SITE DEVELOPMENT PLANS FOR 1360 WALTON BOULEVARD PROPOSED STARBUCKS

Site Plan Review		
Reviewed for compliance to the City Ordinance, Building and Fire Codes		
Department	Reviewer	Approved
Planning	Kristen Kapelanski 248-841-2772 KapelanskiK@RochesterHills.org	Yes
Building	Mark Antinian 248-841-2446 AntinianM@RochesterHills.org	Yes
Engineering	Jason Boughton 248-841-2490 BoughtonJ@RochesterHills.org	Yes
Traffic	Keith Depp 248-841-2503 DeppK@RochesterHills.org	Yes
Nat. Resources	Matt Einheuser 248-841-2551 EinheuserM@RochesterHills.org	Yes
Fire	Capt. Ann Echols 248-841-2701 EcholsA@RochesterHills.org	Yes
City of Rochester Hills Planning & Economic Development		
Conditions and mark-ups noted throughout the plan set must be addressed prior to final approval.

SITE DEVELOPMENT PLANS

PROPOSED STARBUCKS

DRAWING:
C-1

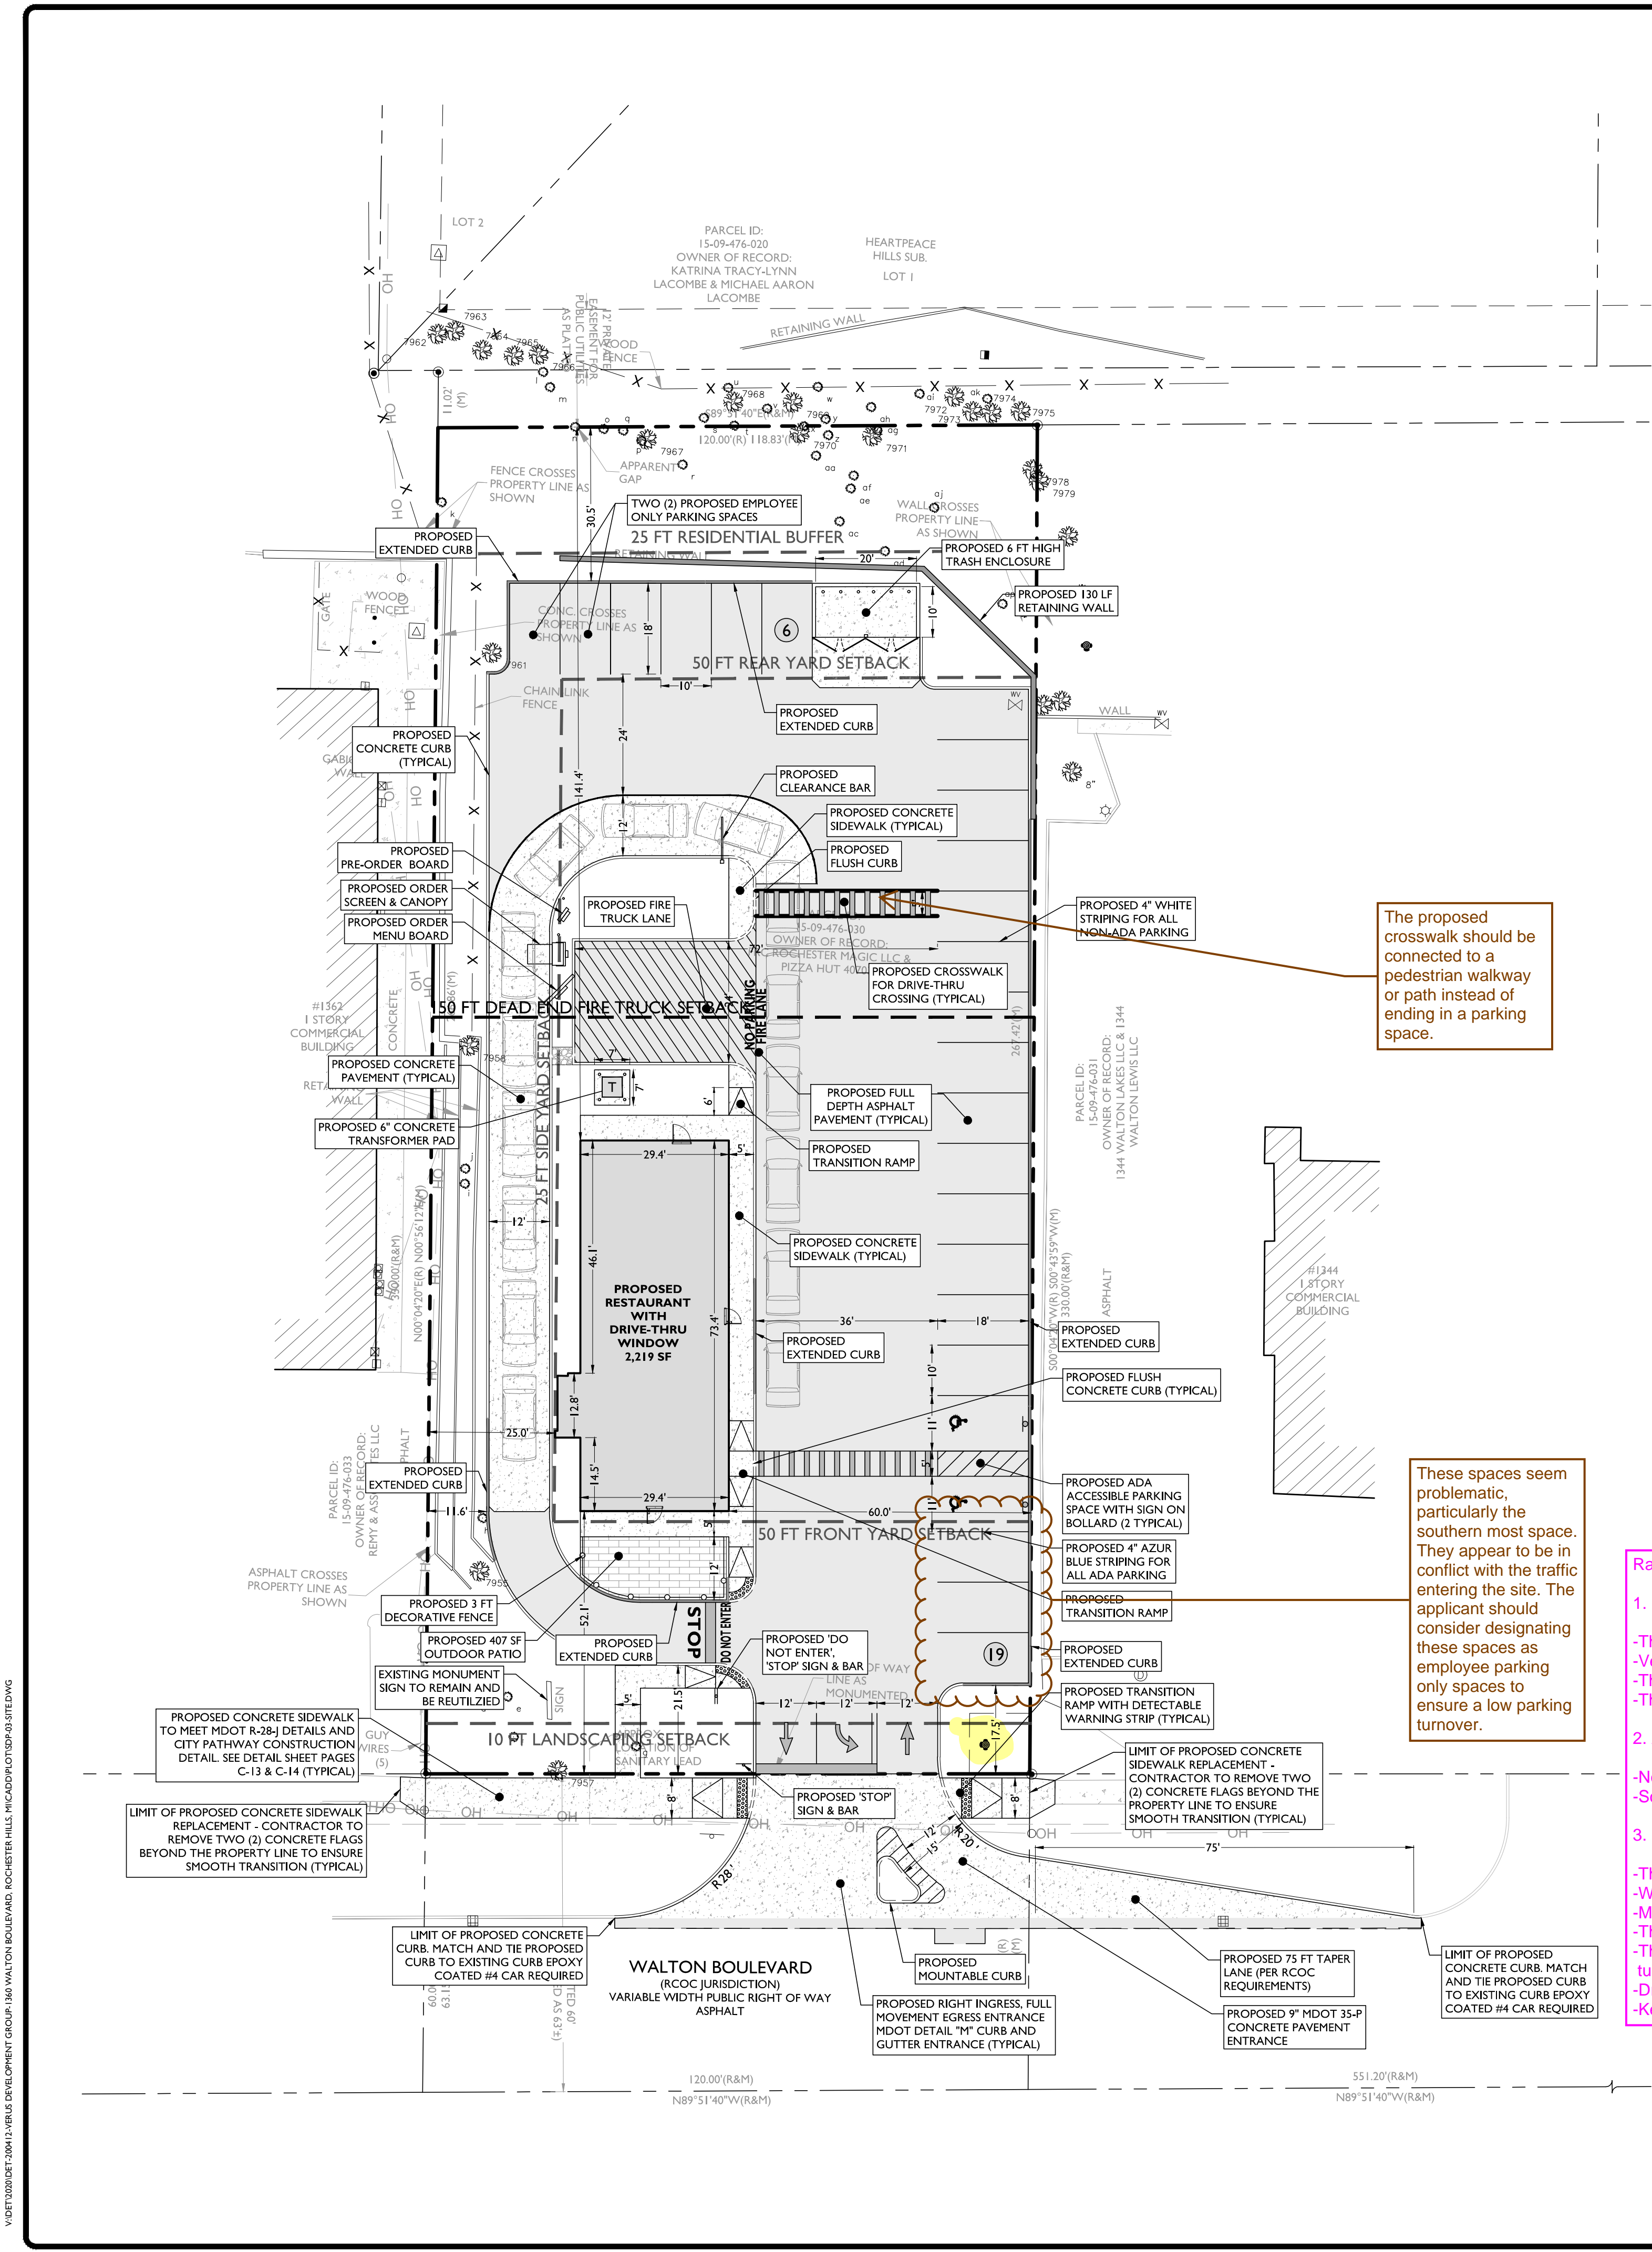
Approved with full access as previously shown not a RI/O as presented here. There are still the potential conflicts regarding the AM peak left turn movements during school arrival time with the proposed Starbucks morning traffic.

See sheet C-3 for further rationale for the full access driveway.

The applicant needs to submit a Land Improvement Permit (LIP) application with engineer's estimate, fee and construction plans to proceed with the construction plan review process.

DRAWING:
C-3

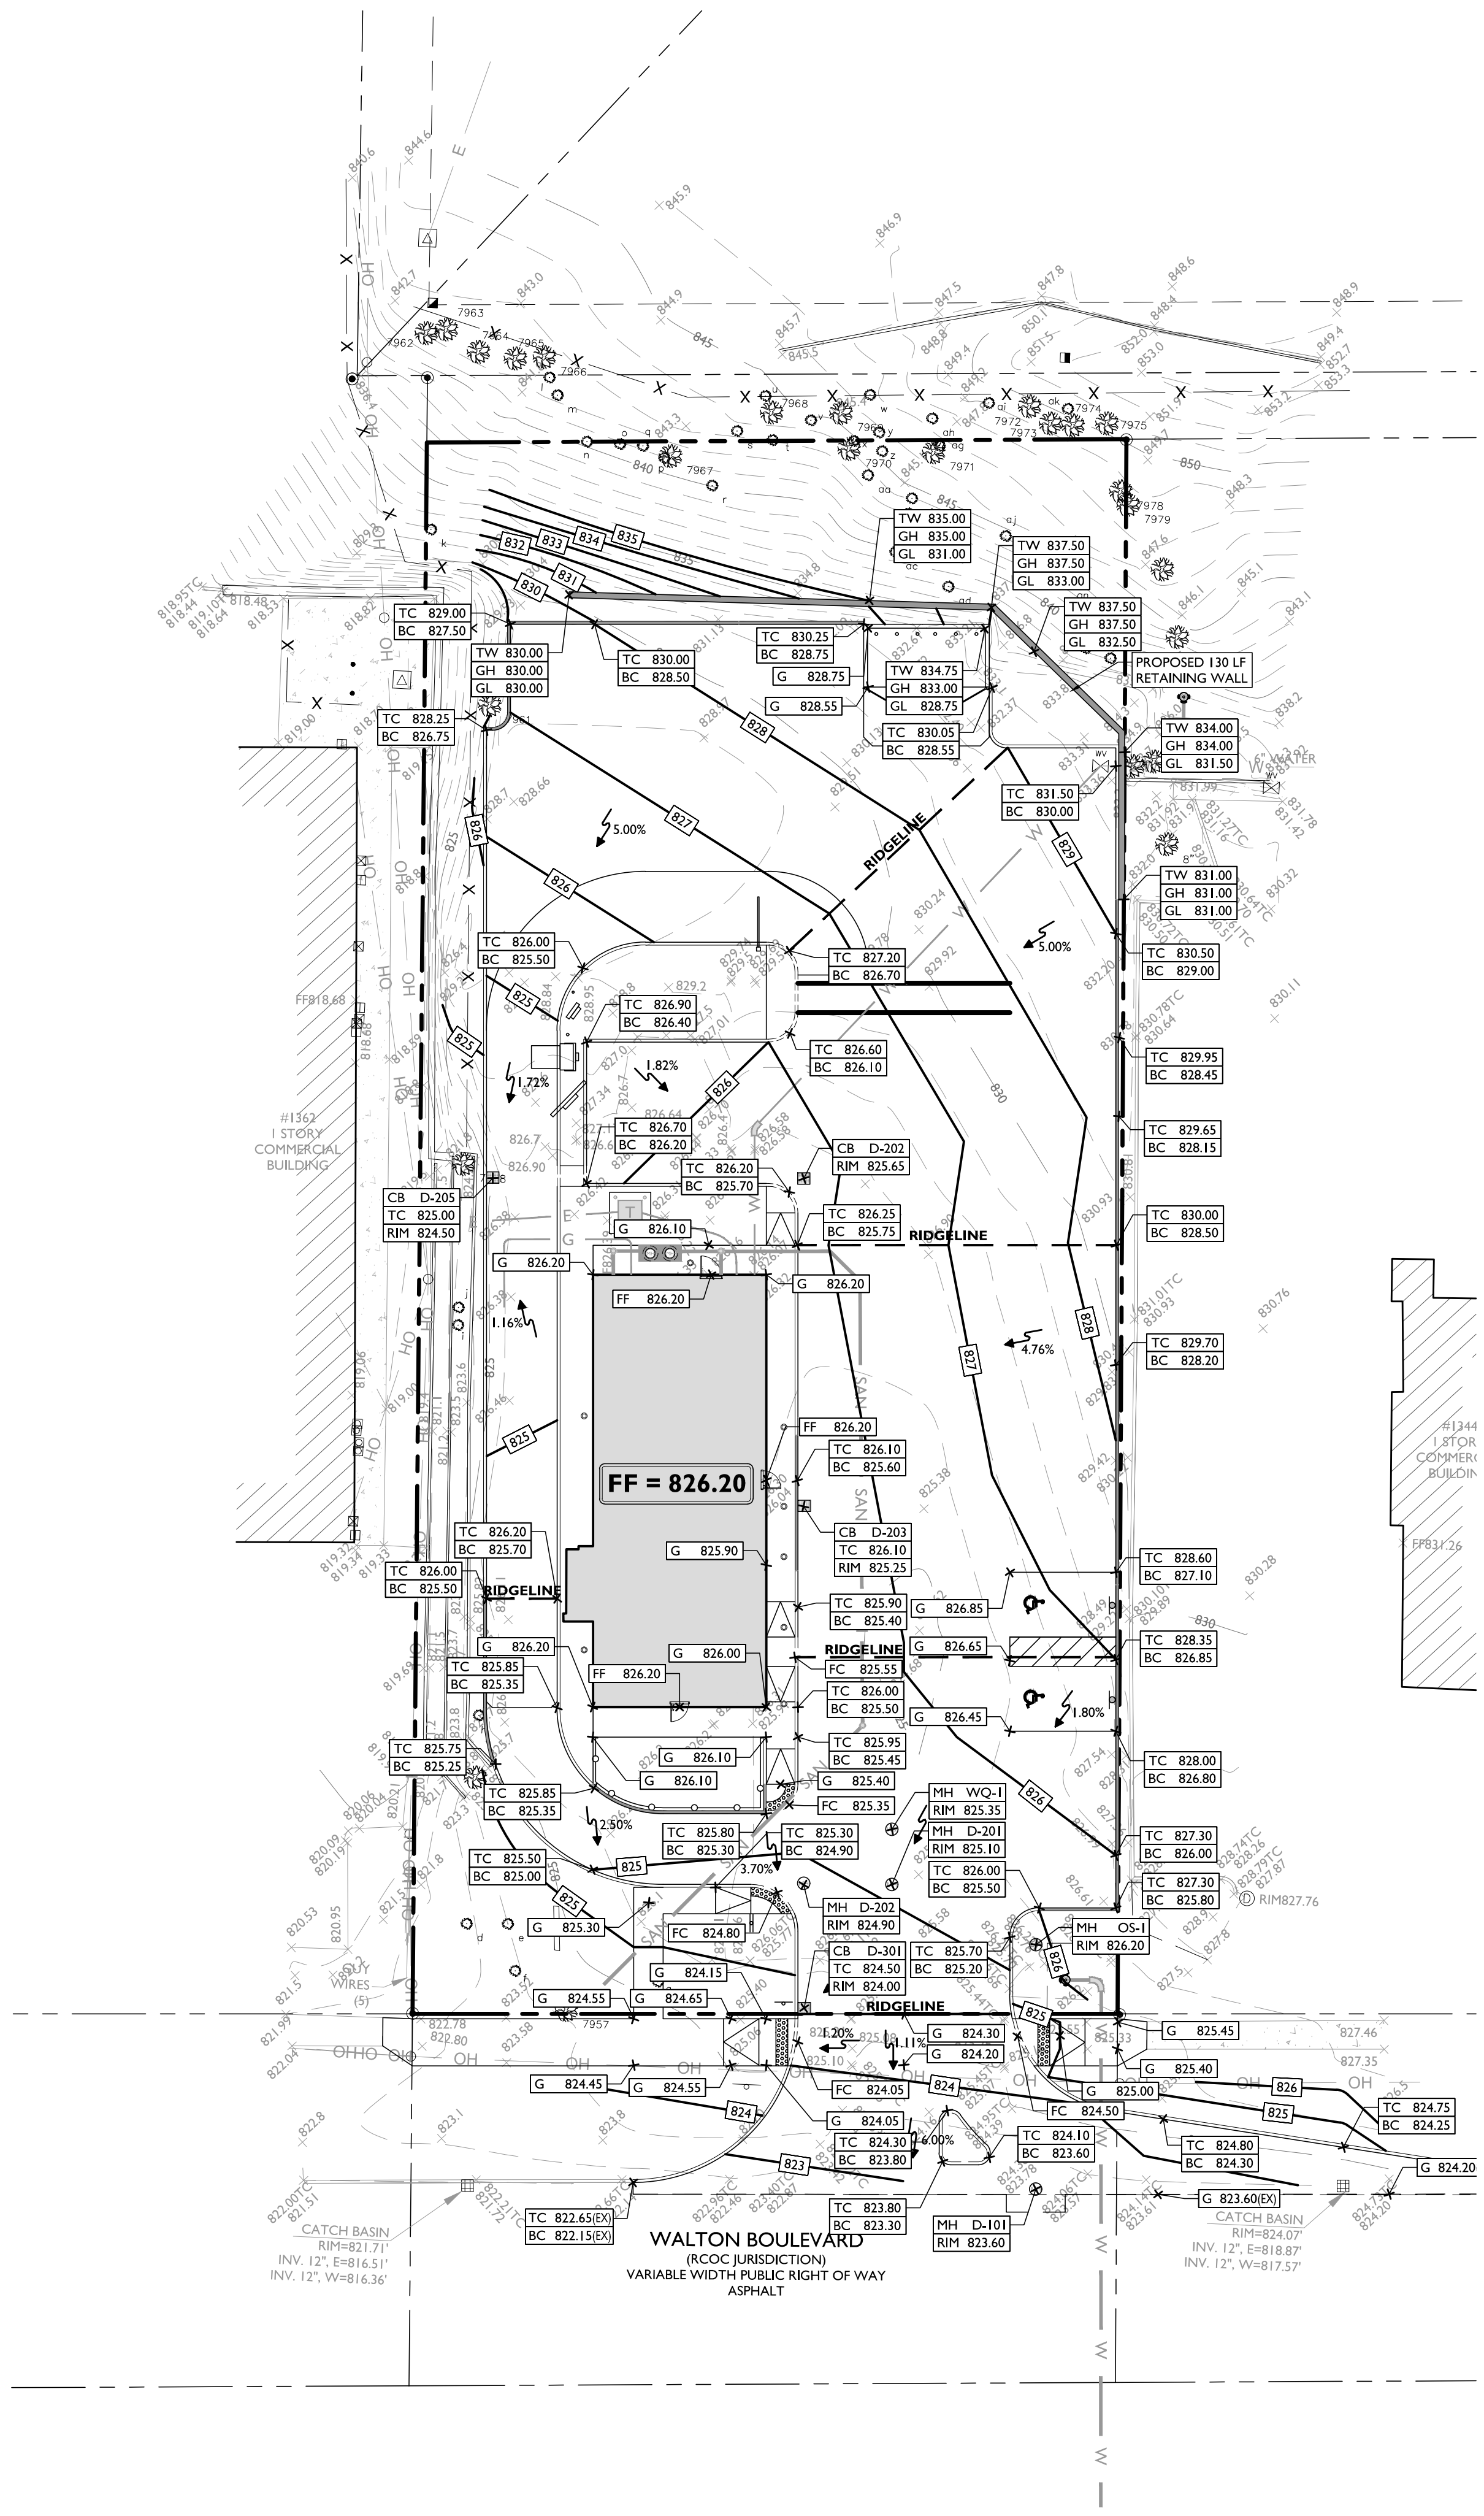
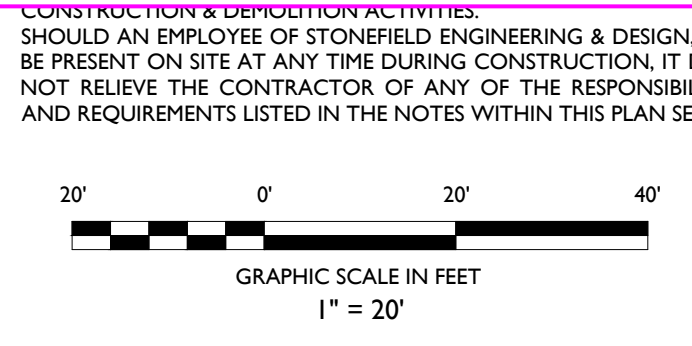
- Rationale for full access drive option, the following would be the order of suggestions:
- Do not permit this type of heavy drive thru use at this location.

- The site itself is very narrow and not deep, which is not ideal for a drive thru coffee shop.
 - Vehicles may pack up into Walton Blvd especially if they are not pulling up as far as they can into the drive thru/parking lot.

- The stacking length is relatively short and only exacerbated the more that drivers don't pull up as far as they can in front of them due to being on cell phones and not paying attention.

- The drive thru itself does not have a bypass lane so patrons parking to go inside will be competing with backing up vehicles when leaving the dining area.

- Allow full access drive (assuming option 1 is not feasible)
 - Not ideal due to the high AM peak use that will be competing with AM school traffic at Rochester High School.

- School and drive thru traffic will be competing for limited CLTL storage length and weaving in and out of the lane to get around staged vehicles.
 - EB Walton Blvd Traffic restricted with NO Lefts into the Driveway Approach

- The compliance rate for EB motorists to adhere to the NO Left turn to enter the site could be low.
 - Would probably need a very low profile curb & gutter raised island to allow emergency vehicles easy access in and out of the site, which makes it more enticing to simply drive over it.

- Maintaining a high compliance rate will only be as good as OCSO ability to provide the necessary resources for adequate enforcement.
 - This would be the only commercial site in the City that we know of with a single drive approach to have turn movement restrictions. All the others have multiple access points.

- This may place an undue burden on Wendy's. Drivers that do comply with the turning restriction will most likely just head EB on Walton Blvd and turn into Wendy's only to do a U-Turn to then head back west onto Walton Blvd to get to Starbucks.

- Drivers that are coming from the east are unlikely to drive head east past the dual lane x-over at Livernois Rd to then head back west onto Walton Blvd.

- Keep in mind that this site only has 1 access entrance where the other locations with the pork-chops islands have multiple options for ingress/egress.
